City of Stamford
Zoning Board

STAFF REPORT

TO: CITY OF STAMFORD ZONING BOARD
FROM: VINEETA MATHUR, PRINCIPAL PLANNER
SUBJECT: **ZB #222-32 100 Clinton Avenue, General Development Plan, Special Permit, Site and Architectural Plan and Requested Uses, Coastal Site Plan Review**
DATE: February 06, 2023

Vehicle Access

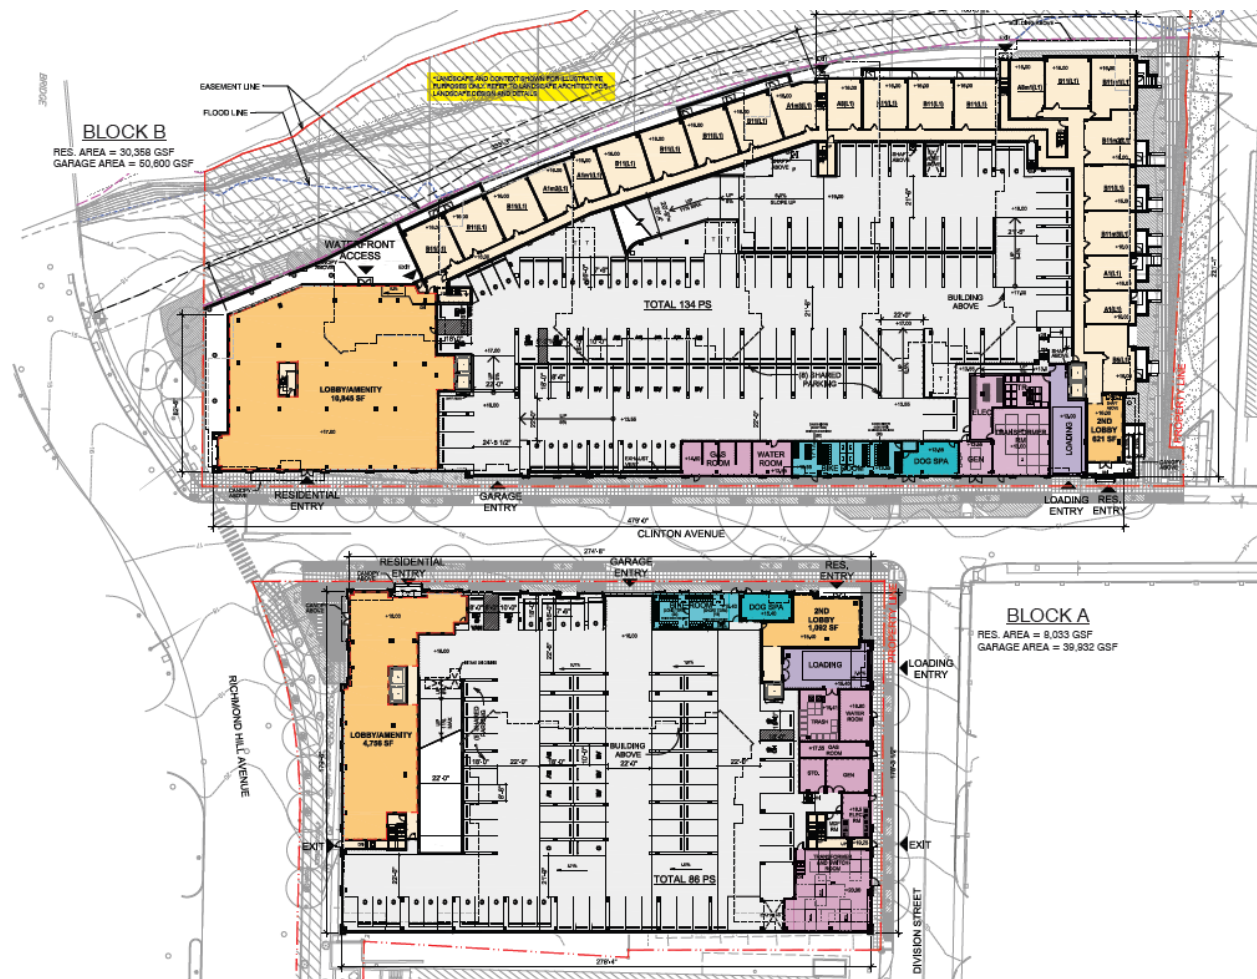
The vehicular access to both buildings (Block A and Block B) is off curb cuts on Clinton Avenue with overhead garage doors. The loading entrance of Block B is located along Clinton Avenue and that of Block A is located along Division Street with dock doors.
